## 7.0 Means of Escape for Disabled People: new provision for evacuation lifts in tall residential buildings

Improvement on existing guidance with new requirement recommendation to improve the evacuation provisions for disabled people by facilitating level egress during an emergency.

Diagram 3.7 Horizontal escape for flats served by a single common stair

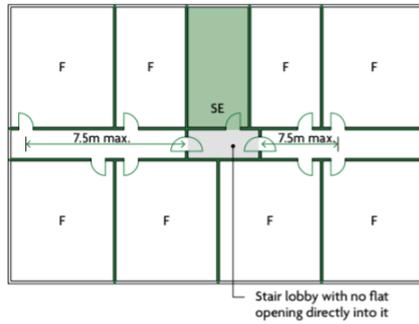
Ref ID	7.03
ADB Volume	1
ADB Paragraph Ref	Diagram 3.7
Title	Diagram 3.7

See para X.X and X.X

- NOTES:**
1. The arrangements shown also apply to the top storey.
  2. See Diagram 3.9 for small single stair buildings.
  3. All doors shown are fire doorsets.
  4. Where travel distance is measured to a stair lobby, the lobby must not provide direct access to any storage room, flat or other space containing a potential fire hazard.
  5. For further guidance on the performance of the fire doorsets from the corridor to the flat and/or evacuation shaft refer to Appendix C, Table C1.
  6. A single common stair arrangement is only suitable for use in buildings with a top storey less than 18m in height (see Diagram D6 in Appendix D).
  7. For components of an evacuation shaft see Diagram 3.xx.

Diagram 3.8 Horizontal escape for flats served by more than one common stair

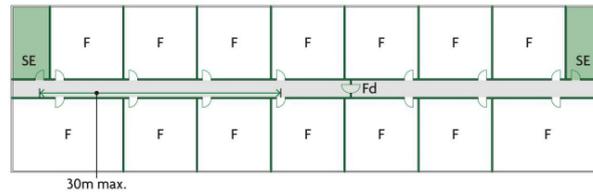
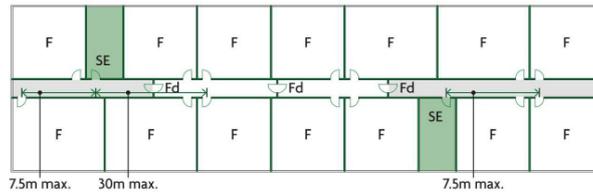
Ref ID	7.04
ADB Volume	1
ADB Paragraph Ref	Diagram 3.8
Title	Diagram 3.8
Current text – 2029 amendment

- NOTES:**
1. The arrangements shown also apply to the top storey.
  2. For further guidance on the fire resistance rating of the fire doorsets from the corridor to the flat and/or stairway refer to Appendix C, Table C1.
  3. For components of an evacuation shaft see Diagram 3.Xi.

Ref ID	7.07
ADB Volume	1
ADB Paragraph Ref	New diagram, in new subsection <b>Evacuation lifts and evacuation shafts</b> after new paragraph 3.v
Title	Diagram 3.Xi Evacuation Shaft Diagram
Current text – 2029 amendment	n/a
Proposed text

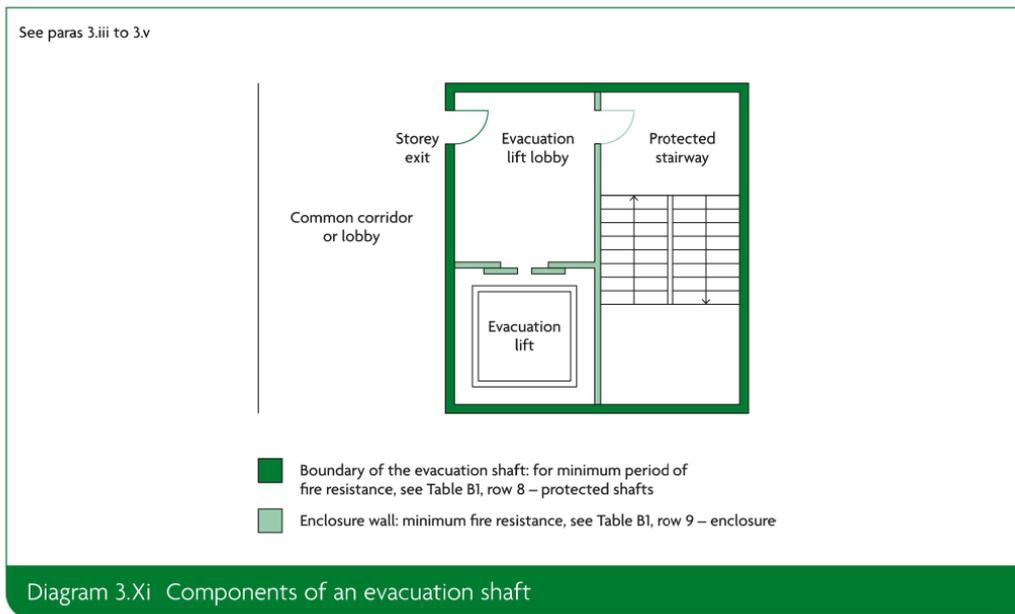
3.iv Each evacuation shaft should contain a protected stairway, at least one evacuation lift and an evacuation lift lobby at each storey served by the lift. See Diagram 3.Xi.

3.v An evacuation lift lobby should provide a protected area for those waiting for the evacuation lift, have direct access to a protected stairway and not be directly accessible from any flat, maisonette, storage room or electrical equipment room. An evacuation lift lobby may serve multiple lifts within the same evacuation shaft.
